RE: AIS Circulation- Overall Grading Plan for Roads

**Grading Plan**

RE: AIS Circulation Grading Plan (H13\_D106)
Response to Hydrology Email Comments

**To:** Diane Hoelzer < diane@goodwinengineers.com > **Subject:** H13D106 - AIS Circulation - Stamp 11-15-2016

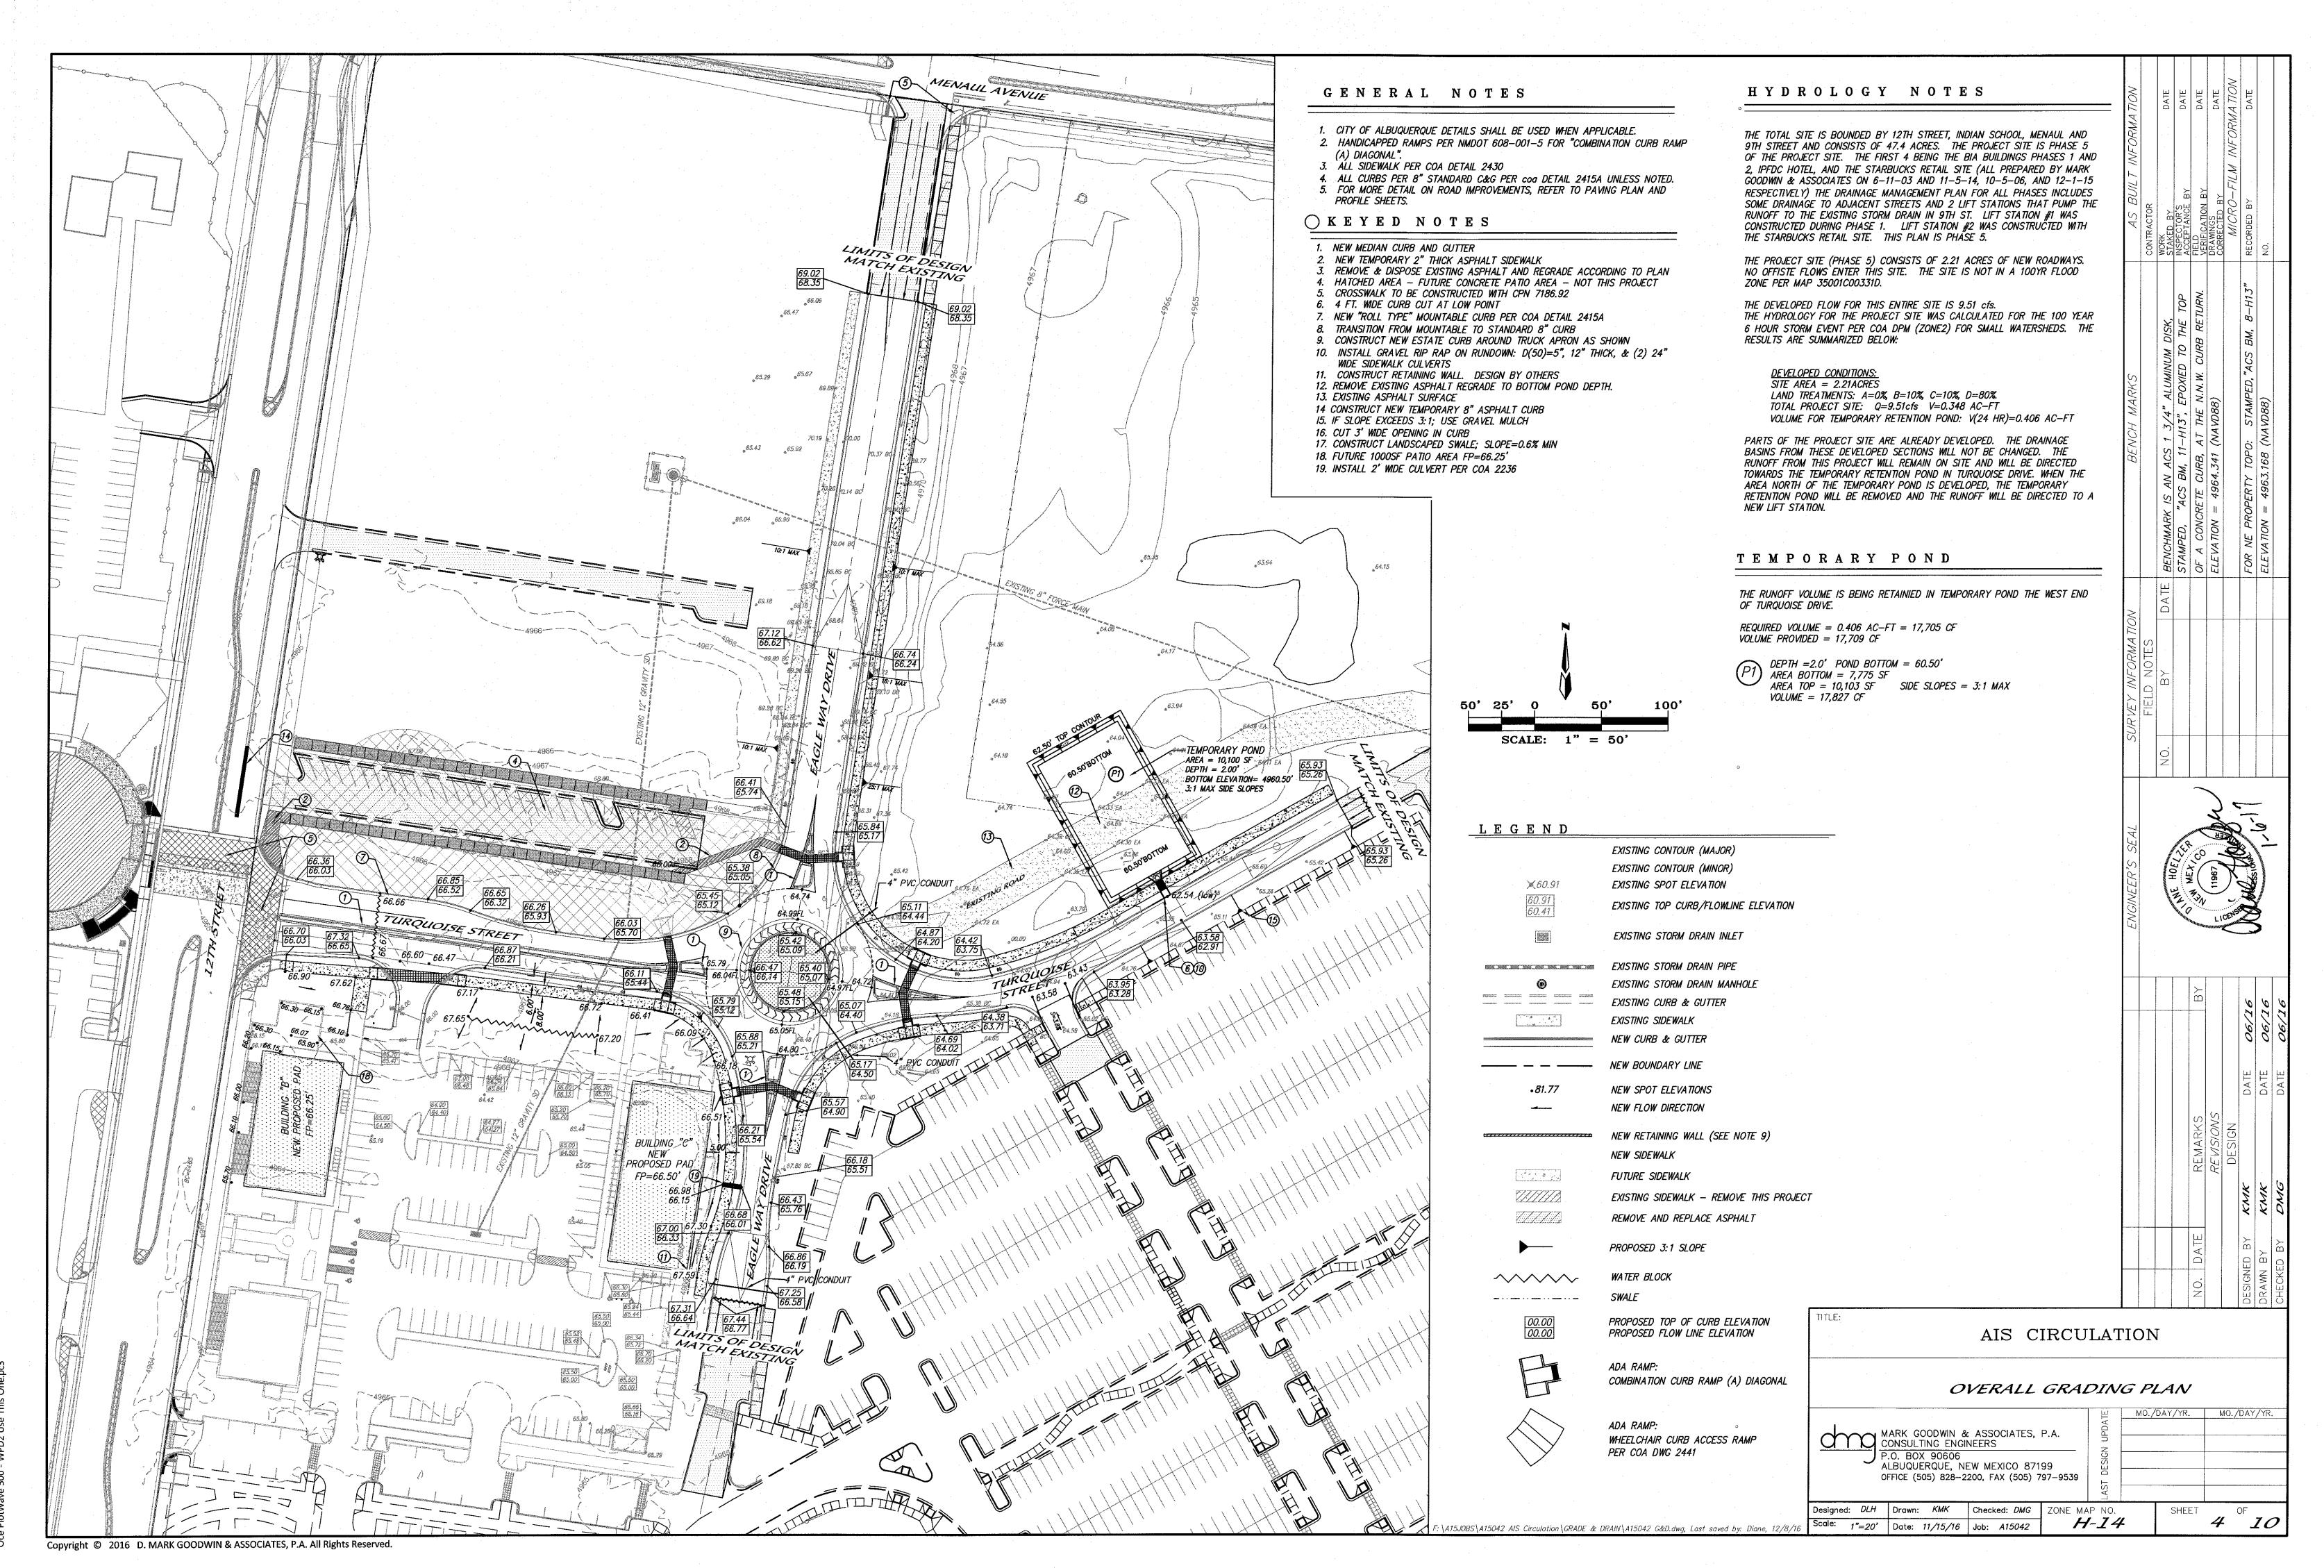
- 1. Provide cross sections for the roadways (preferable), or otherwise make it clear which legs are crowned, and provide elevations for median and sidewalk segments that are not labeled. This is a general rough grading plan that is part of a construction plan set that includes paving plan and profiles. The master paving plan is part of this resubmittal as it show the typical road cross sections and sidewalks which are place above the curb at a typical 2% cross slope.

- 2. Clarify the rip rap and low spot for the pond rundown, the sidewalk should not dip down into a rip rap pad. The rip rap will only be placed on the side slope extending into the pond. The rundown has been modified to include (2) standard 24" wide sidewalk culverts with the standard grate plate.

- 3. It appears that the northern leg of Eagle Way transitions from crowned section to flat grading near the force main line; the running slope to the roundabout is only about 0.6%, which is difficult to achieve in the pavement. Consider transitioning out of the crown closer to the roundabout. On the north leg of Eagle Way Drive, at the crown transition, there is a 0.3'drop across 38' which translates to a 0.78 % cross slope. I have shifted the crown transition 50' south to the location where the cross slope is 1.0%.

- 4. Provide a detail for the rundown, including any ramping from the sidewalk and/or sidewalk culverts intended. The rundown has been modified to include (2) 24" wide sidewalk culverts.

- 5. On the southern leg of Eagle Way Drive, provide better direction to the Contractor on how to set the elevation of the sidewalk so as to prevent a slope steeper than 3:1. If possible, provide a flatter slope to prevent such a steep drop off from the edge of the sidewalk to the back of the curb. The typical roadway sections show the sidewalk is to be constructed in the standard location offset from the top of curb at a consistent 2% cross slope, so there is no area where the landscape area between the sidewalk and back of curb is 3:1. Also, we are lowering the grades in this area, so there is not a 3:1 slope. The plan notation has been revised accordingly.

- a. If 3:1 slopes are found to be necessary, provide designed erosion control (vs only noting that gravel mulch is needed). They are not necessary.
- The median islands should be planned with standard or median curb to better protect
  pedestrians between lanes at the roundabout. Its all median curb and gutter per COA DTL.
  2415B.

- 7. Transition to depressed curb where the flow is conveyed across the pavement, such as around the curve from Eagle Way to Turquoise Street. I don't understand why this is necessary. Please explain. These roads are private and not part of a work order plan set. However, I am changing the roundabout median curb and gutter to "median depressed curb and gutter.
